**TOWN OF BROOKLYN
PLANNING AND ZONING COMMISSION
Regular Meeting Agenda
Wednesday, November 4, 2020
6:30 p.m.**

As you requested, I have reviewed the developer's consulting engineer's plans for the above captioned project. A copy of my comments are enclosed pertaining to my review of the plans, consisting of five sheets, entitled "Proposed Parking Expansion, 'Vachon Chevrolet', Providence Road (Route 6), Brooklyn, Connecticut, Prepared for Vachon Brooklyn, LLC.," which were created by Killingly Engineering Associates, dated January 2020 with revision date of March 10, 2020.

ENGINEERING PLAN REVIEW PERTAINING TO PROPOSED PARKING EXPANSION VACHON CHEVROLET (ASSESSOR'S MAP 41, LOTS 13A & 14) PROVIDENCE ROAD (ROUTE 6) BROOKLYN, CT (March 20, 2020)

SHEET 3 OF 5 – SITE DEVELOPMENT PLAN No. 1

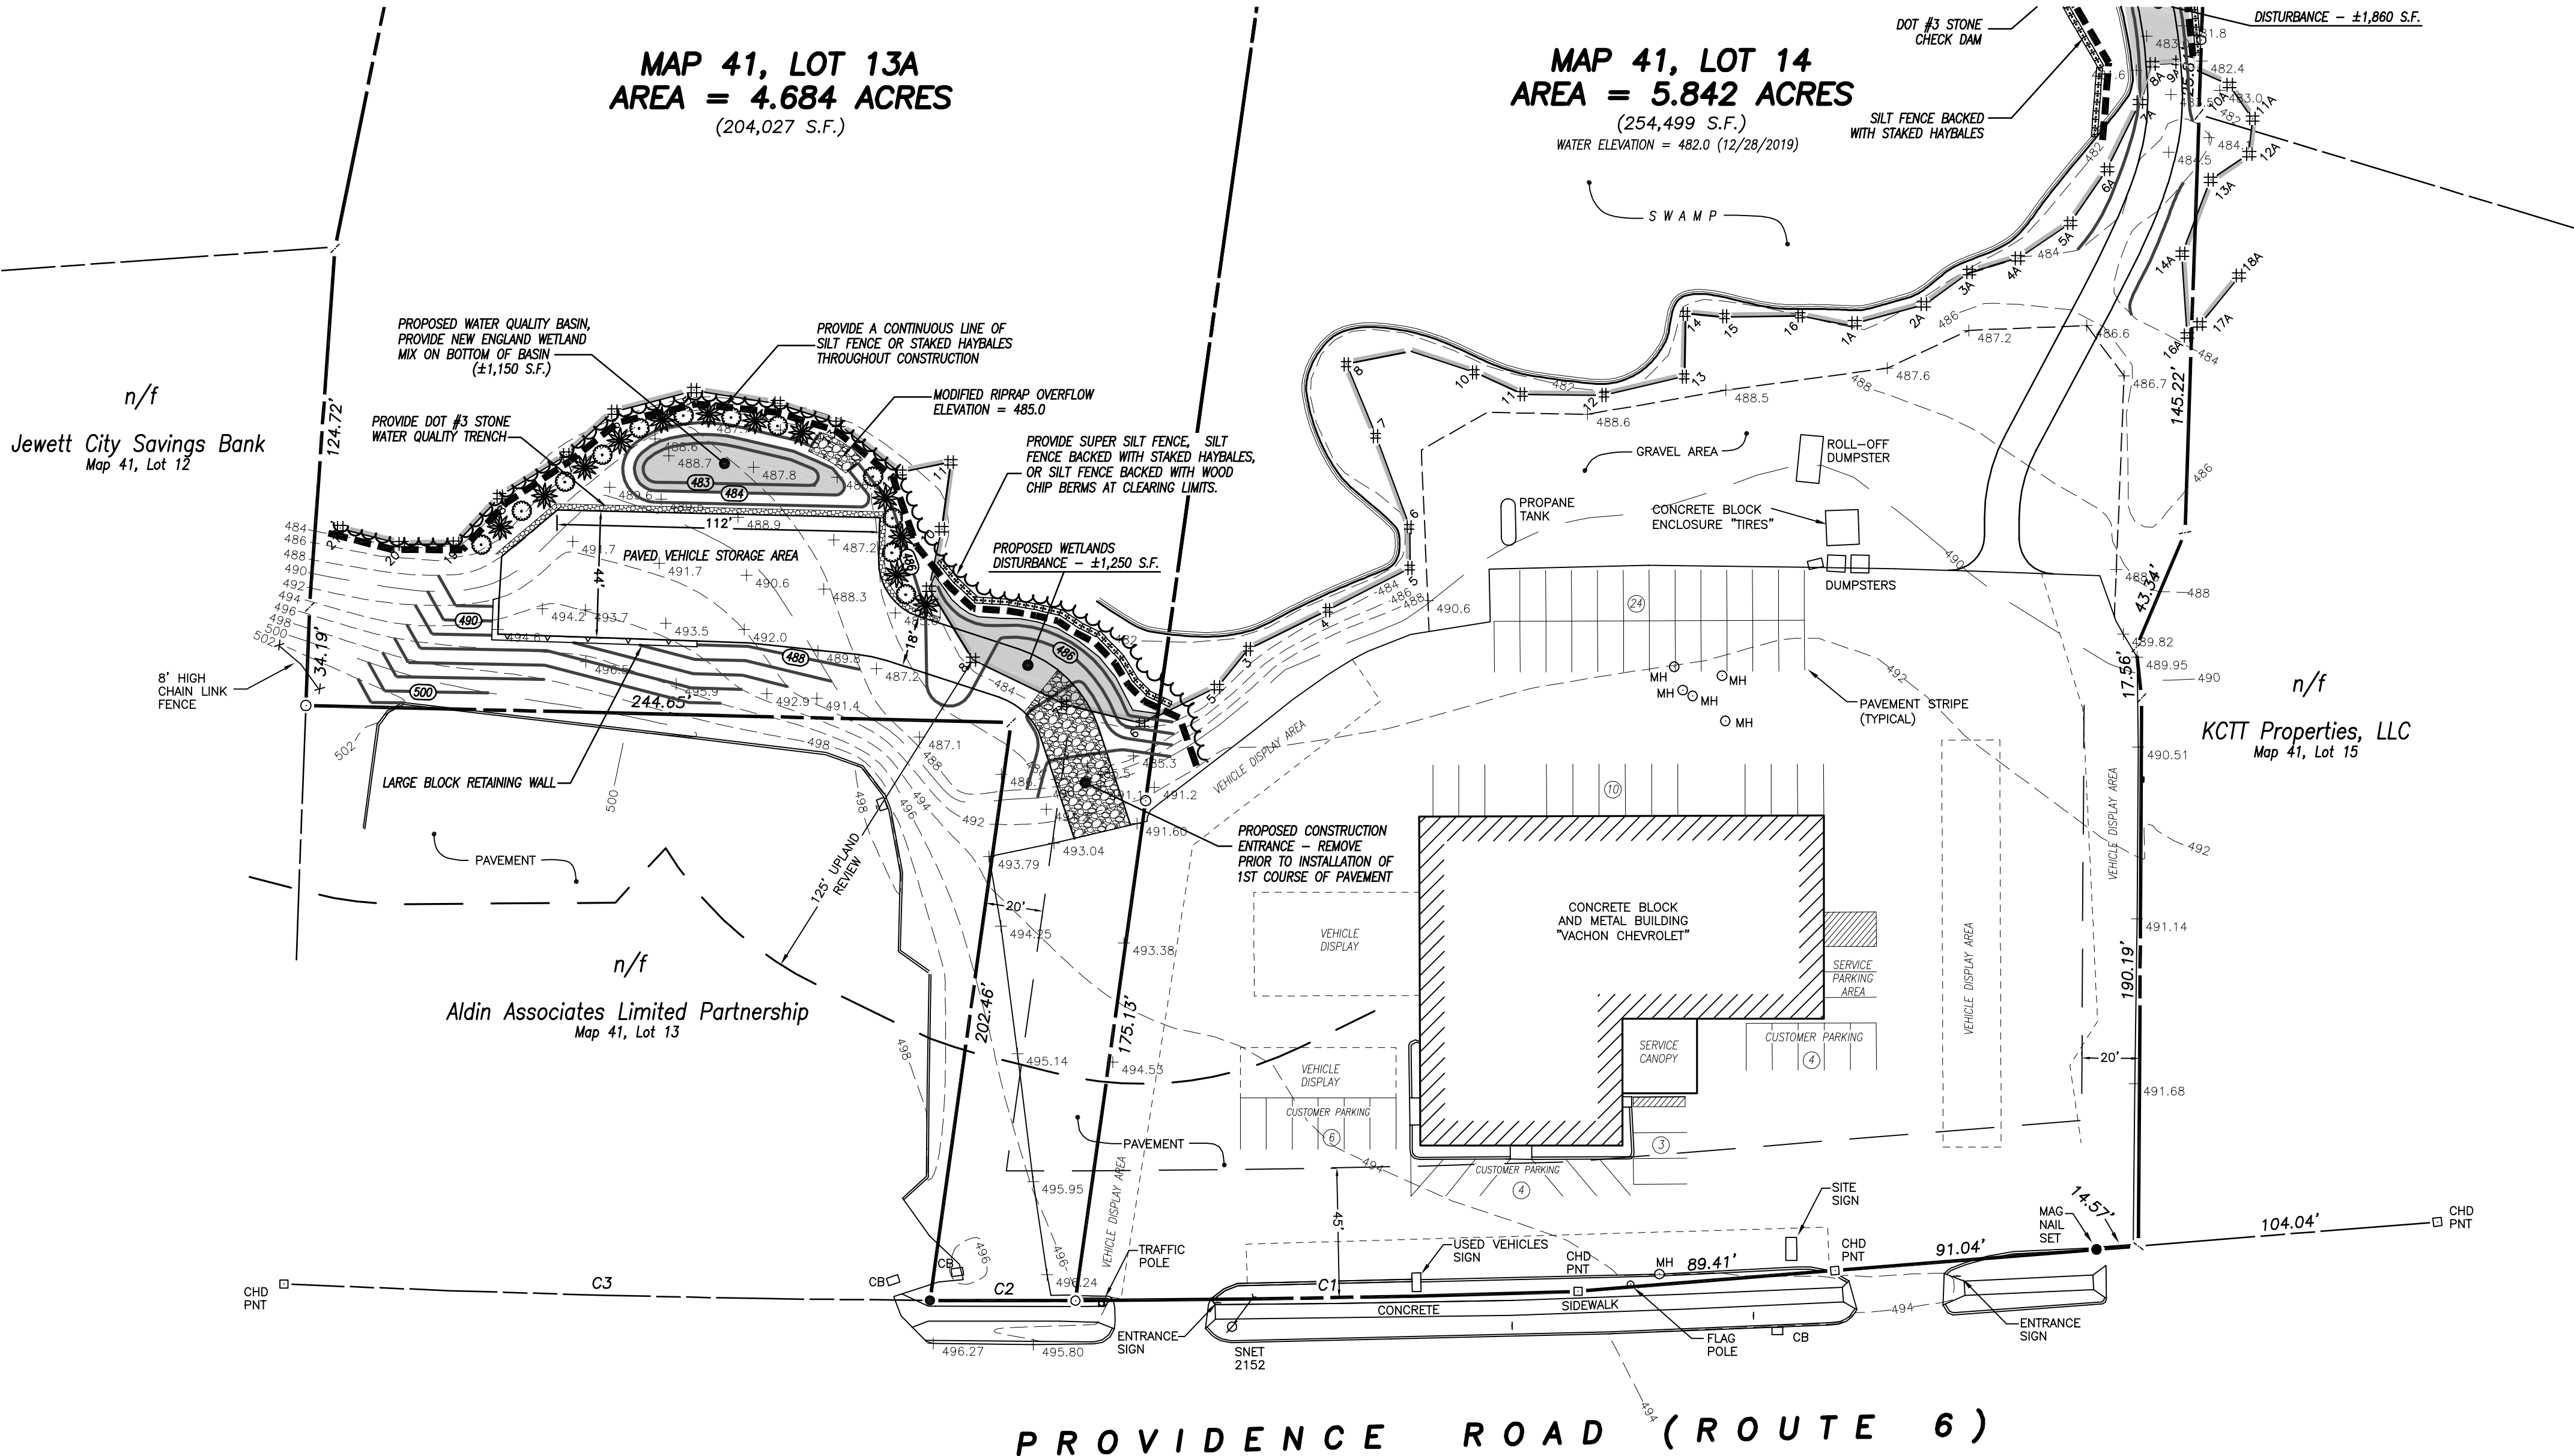
1. A construction entrance symbol is drawn at the entrance to the new "paved vehicle storage area." However, a note should be included to indicate that this will be removed at the time the first course of paving is installed for the vehicle storage area. Additionally, it would be helpful for this explanation to be included in Note 17 under "Development Schedule/Sequence of Operations" that appears on Sheet 5 of 5 of the plan set.
2. The note "Silt Fence Backed with Staked Haybales or Wood Chip Berms" should read the same as the note on Sheet 4 of 5, "Provide Super Silt Fence, Silt Fence Backed with Staked Haybales, or Silt Fence Backed with Wood Chip Berms at Clearing Limits," for consistency.

1. A note has been added to the plan to direct the contractor to remove the anti-tracking construction entrance prior to installing the first course of pavement. This has also been noted on sheet 5 of 5 in the development schedule/sequence of operations.
2. The note "silt fence backed with staked haybales or wood chip berms" has been modified to read the same on all sheets.

LIGHT STANDARD
NOT TO SCALE

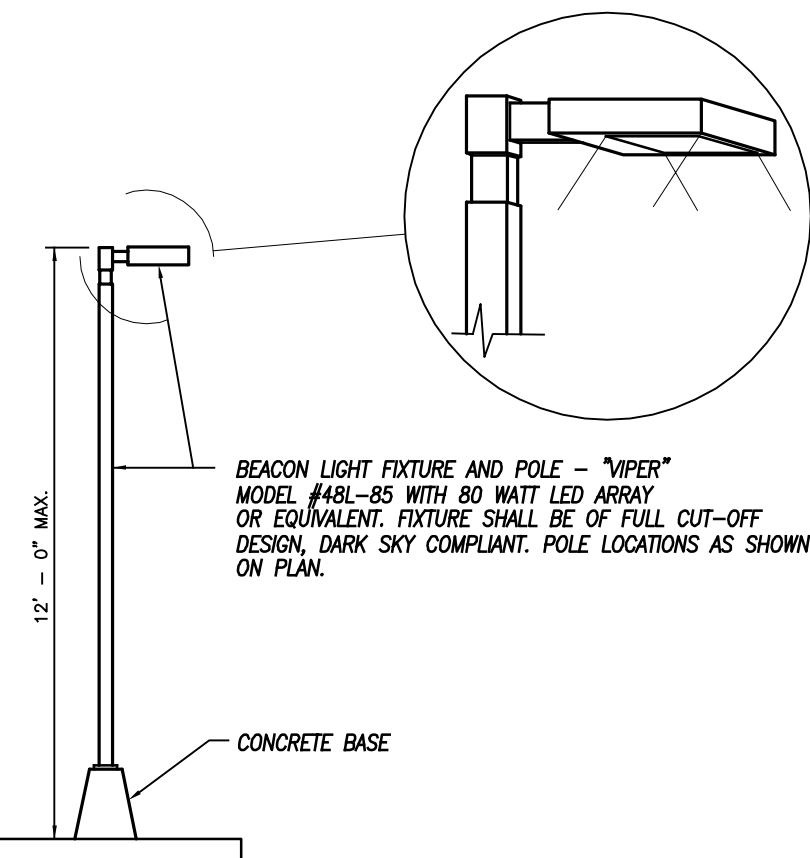
majority of the visual/sound barrier created by the existing mature forest in this area between the house and the proposed development is going to be removed, only to be replaced by young plantings that will take many years to reestablish the buffer. Therefore, has the impact of lighting and noise on the adjacent residence been evaluated to determine if there will be any significant impact to it?

2. A detail for the lighting fixture with the make and model number has been added to the plans. We have also enclosed a cut sheet for the lighting as well. The chosen fixtures will be mounted no higher than 12' and are dark sky compliant. In addition, the landscaping proposed between the parking and the residences to the north will provide a very good vegetated buffer; cut sheets for the chosen plantings is included with this submission. Currently, the existing pine trees do not provide any visual buffer. As with most larger pine trees, there are minimal branches at the bottoms of the trees up to 20' or more. With regard to noise, this area will be utilized to store inventory and will not be accessed by the general public unless accompanied by a sales representative.

SHEET 4 OF 5 – SITE DEVELOPMENT PLAN No. 2

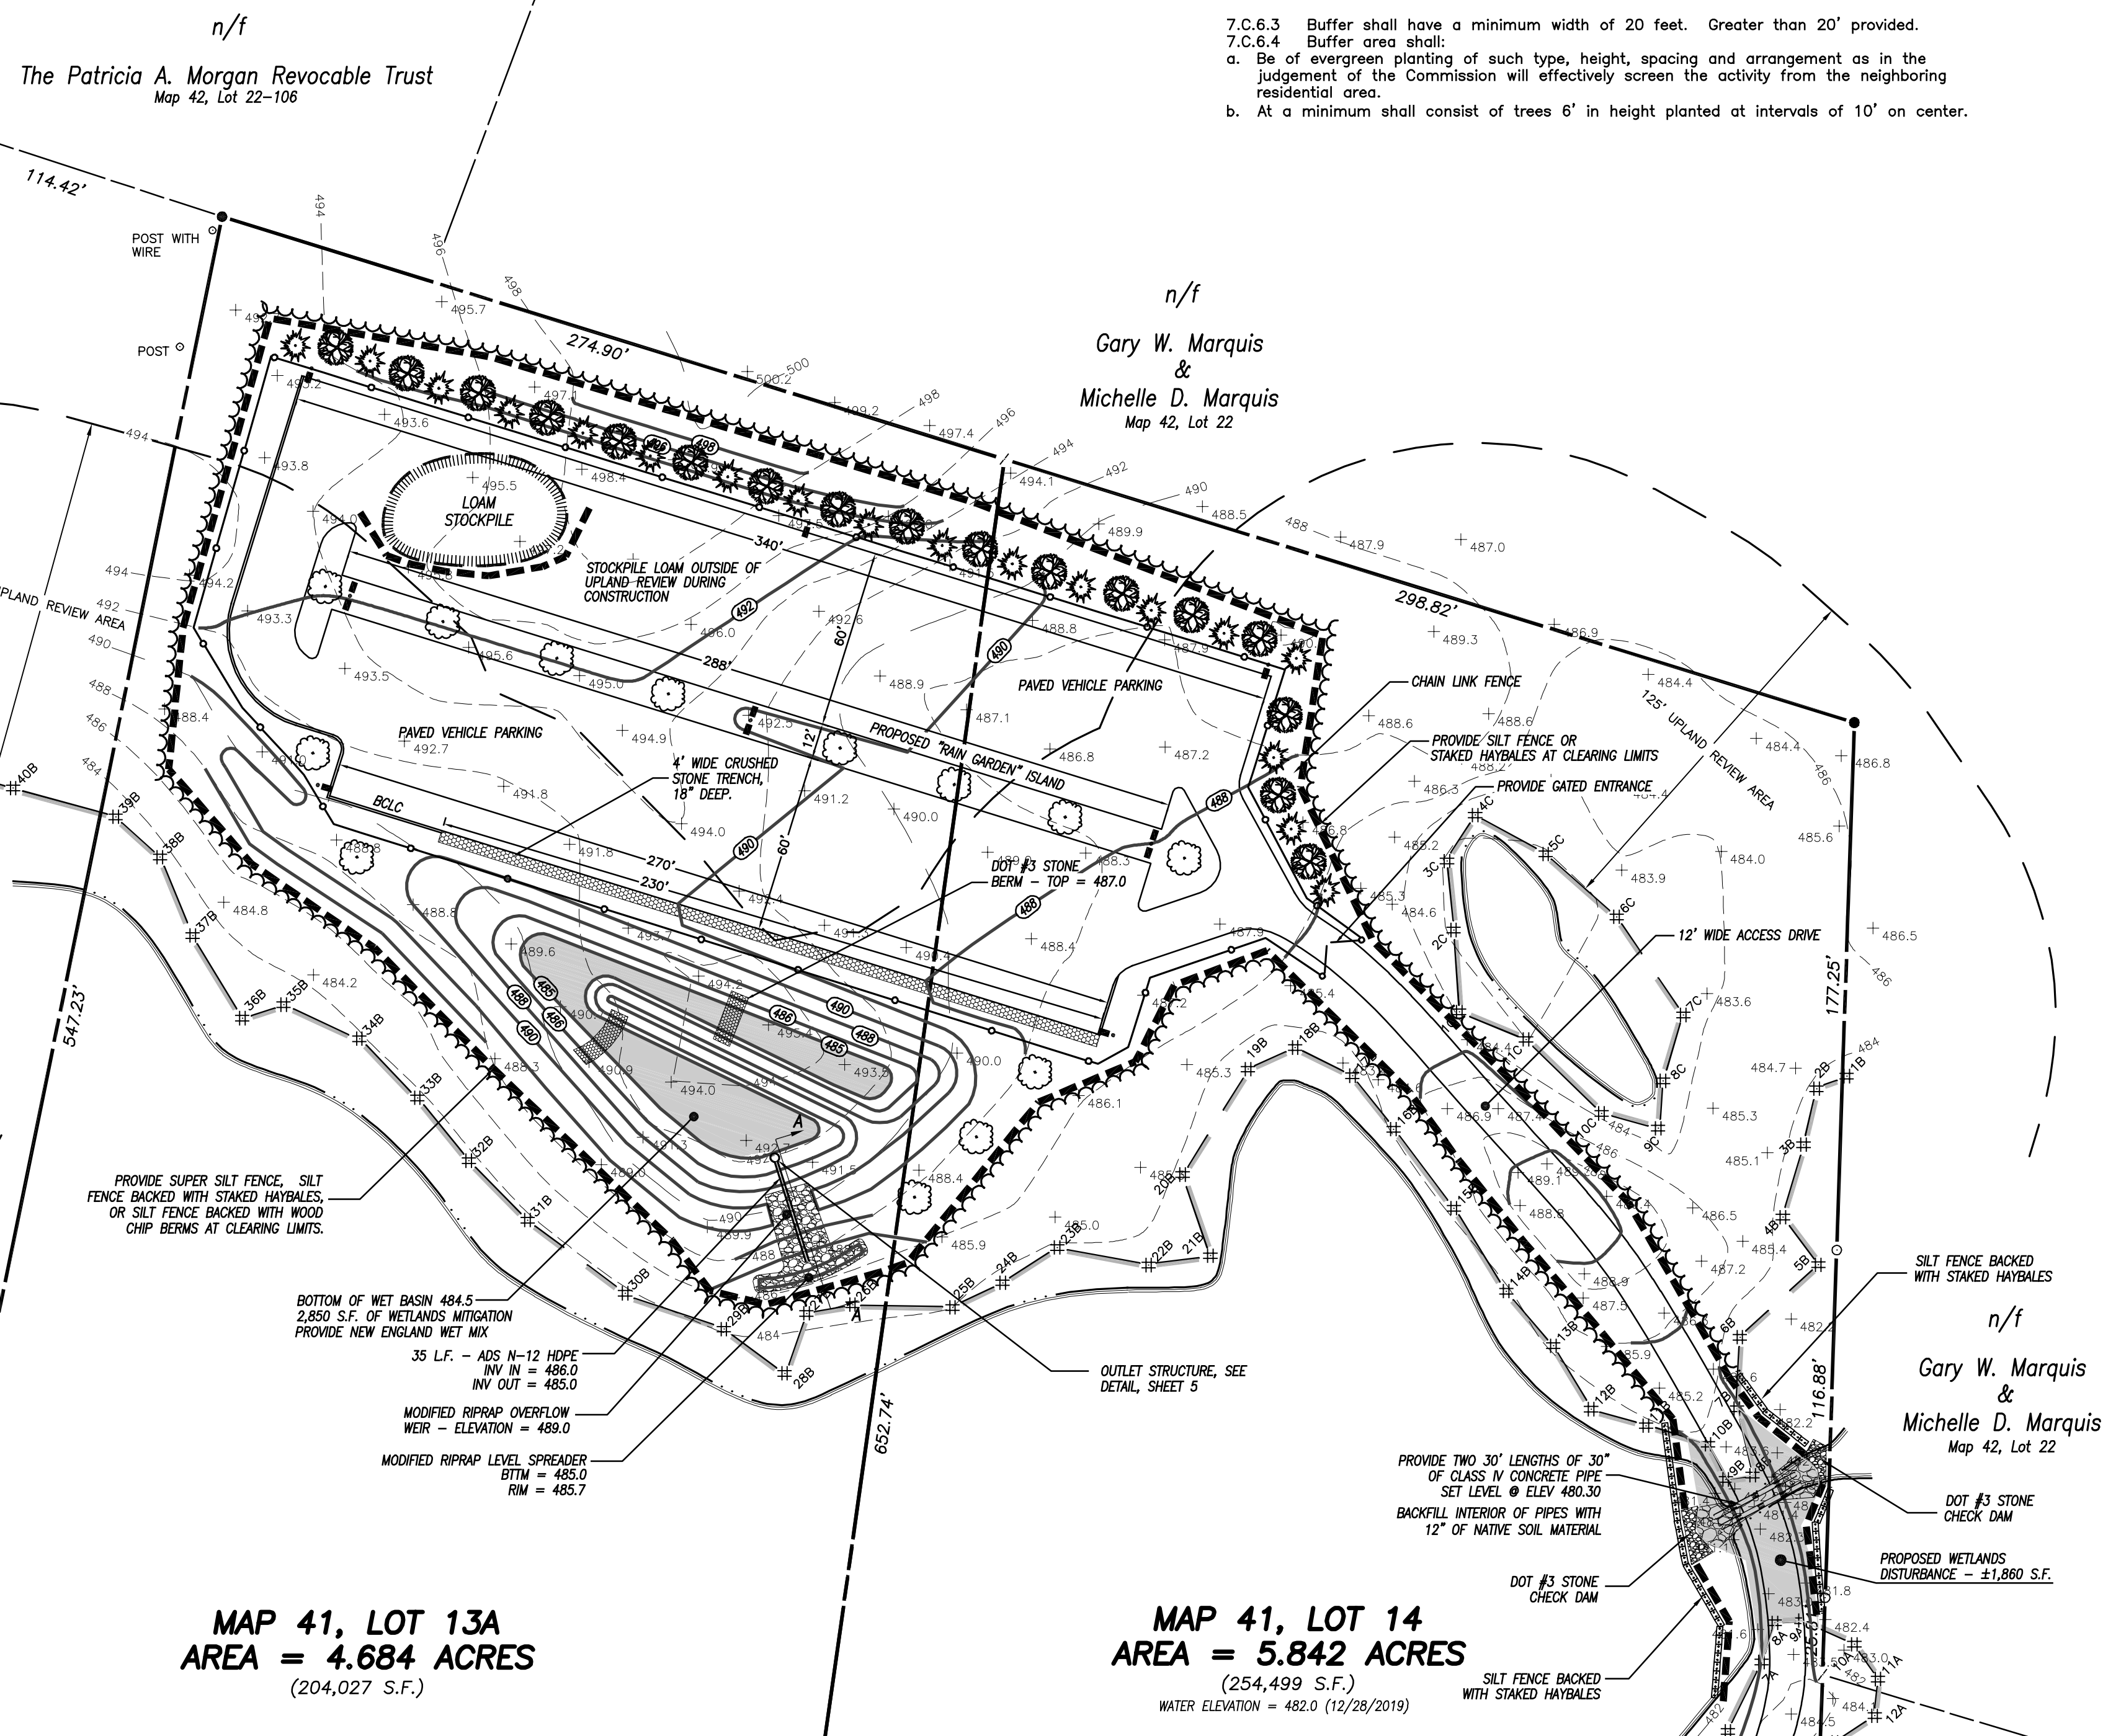
1. Proposed slopes in the detention basin range from 1:1 to 3:1. It is recommended that slope be uniform and that no slopes be steeper than 3:1 to reduce the tendency of soil erosion
2. Pedestal lighting, with dual light fixtures, is shown at three (3) locations in the middle of the proposed vehicle parking area. No description of the lighting assembly (pedestal height, pedestal base, full cutoff design, wattage, etc.) can be found in the plans under review. This is important since there is a house on adjacent Lot No. 22 that is not too distant from the north property line in the vicinity of the proposed construction on the Vachon property. It should also be noted that the

3. How will snow removal be handled in this area so as not to impact the adjacent wetlands (salt or other ice removal chemicals) and proposed landscaping?
4. It is unclear on how the "island" in the middle of the proposed parking area is going to be constructed, i.e., raised island with landscaping; raised island paved with no landscaping; flush with whatever in between; etc.? Can this area be used as a rain garden to mitigate some of the runoff from the pavement?
5. Is there any consideration to provide some form of "tall" landscaping in the center island, considering how much impervious pavement is being proposed?
6. As an aid to construction, it would be helpful to include a cross-section profile from the detention basin outlet structure to just beyond the level spreader.

1. Slopes in the detention basin have been modified so that they do not exceed 2:1 (center berm only). We have also noted that jute netting shall be installed to stabilize the basin after topsoil and seed have been applied. The center berm is designed to extend detention time in the basin and we do not anticipate erosive conditions once stabilized.

3. Snow will be stockpiled at the top of the slope adjacent to the proposed stormwater basin. Sheet 5 of the plans specify that no salt or chemical applications for snow removal shall be used.

4. The island in the center of the site will be depressed. We will incorporate rain garden plantings into the island to promote stormwater treatment and infiltration.
5. As the center island will be utilized in the capacity of a rain garden, we do feel that taller vegetation would be appropriate.
6. A cross section of the basin outlet has been added to the plans as requested.

SILT FENCE - BACKED WITH HAYBALES

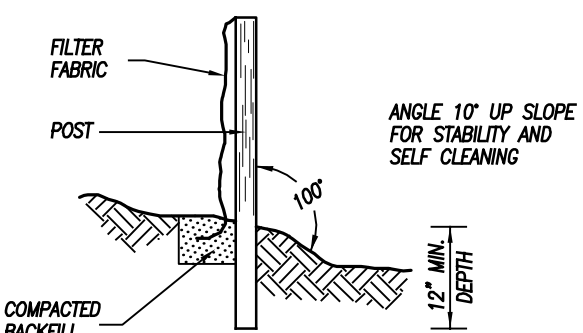
3. It is recommended that the "Silt Fence – Backed with Haybales" detail title be modified to read "Super Silt Fence (Silt Fence Backed with Haybales or Wood Chip Berms)."

2. For the stone berm, specifications for the filter fabric have been called out and conditions for maintenance are defined.
3. The silt fence detail has been modified to read "super silt fence" as requested.

BITUMINOUS CONCRETE LIP CURBING

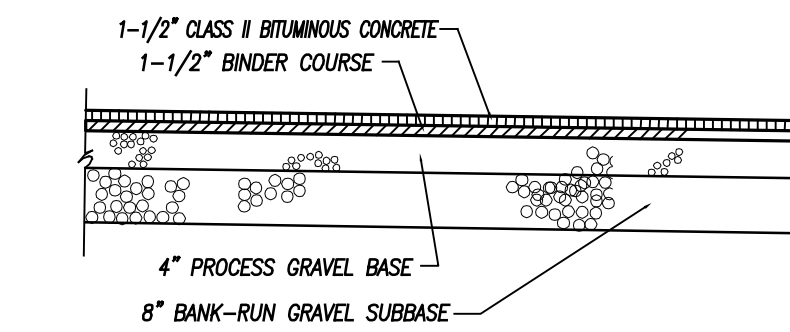
7. In the "Bituminous Lip Curb" detail it is recommended that the curb be formed on the binder course (locked in) for better stability/longevity, which should provide more resistance to deformation by snowplowing operations or other vehicle impacts.

6. We have modified the slope stabilization detail to call for application on slopes 2:1 or flatter per 5-4-10 of the 2002 Guidelines.
7. Bituminous curb installation detail has been modified accordingly as requested.
